TWR SUBDIVISION, UNIT ONE, RESUBDIVISION OF LOT 2

APPLICATIO	N NUMBER _	27	_ DATE _	April 7, 2005	- N
APPLICANT	APPLICANT TWR Subdivision, Unit One, Resubdivision of Lot 2				
REQUEST	Subdivision				_ 1
					NTS

TWR SUBDIVISION, UNIT ONE, RESUBDIVISION OF LOT 2

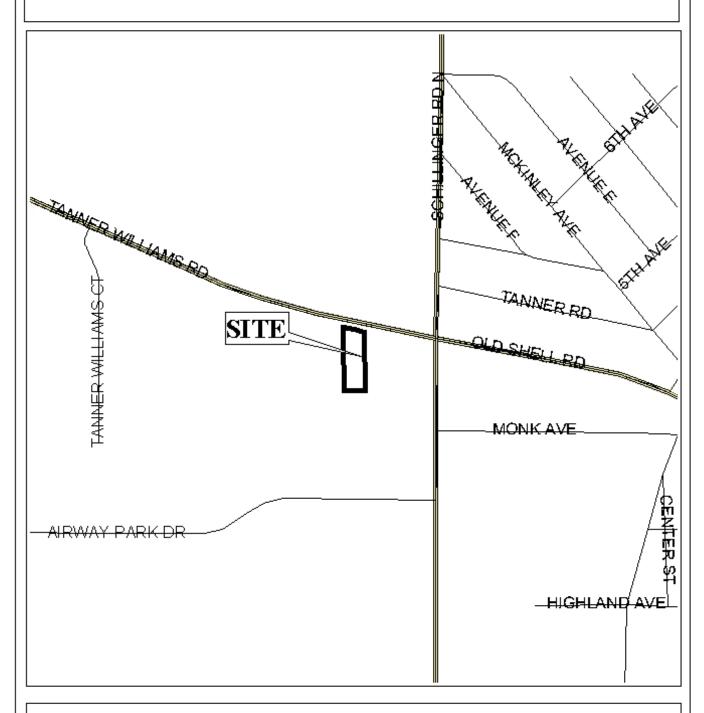
As proposed, Lot B would be a flag-shaped lot, with only 30'± of street frontage, which would be inconsistent with the pattern of development in the area, a factor considered by Section V.D.1 of the Regulations (size, width depth, shape and orientation of lots shall be appropriate to the location of the subdivision). The site would also exceed the maximum depth to width ratio of 3.5 allowed by Section V.D.3 of the Regulations.

Based upon the preceding, this application is recommended for denial for the following reasons: the plat would exceed the maximum depth to width ratio as recommended by Section V.D.3. of the Subdivision Regulations; and 2) the plat would not comply with Section V.D.1. of the Subdivision Regulations which state that "the size, width, depth, shape, and orientation of lots…shall be appropriate to the location of the subdivision."
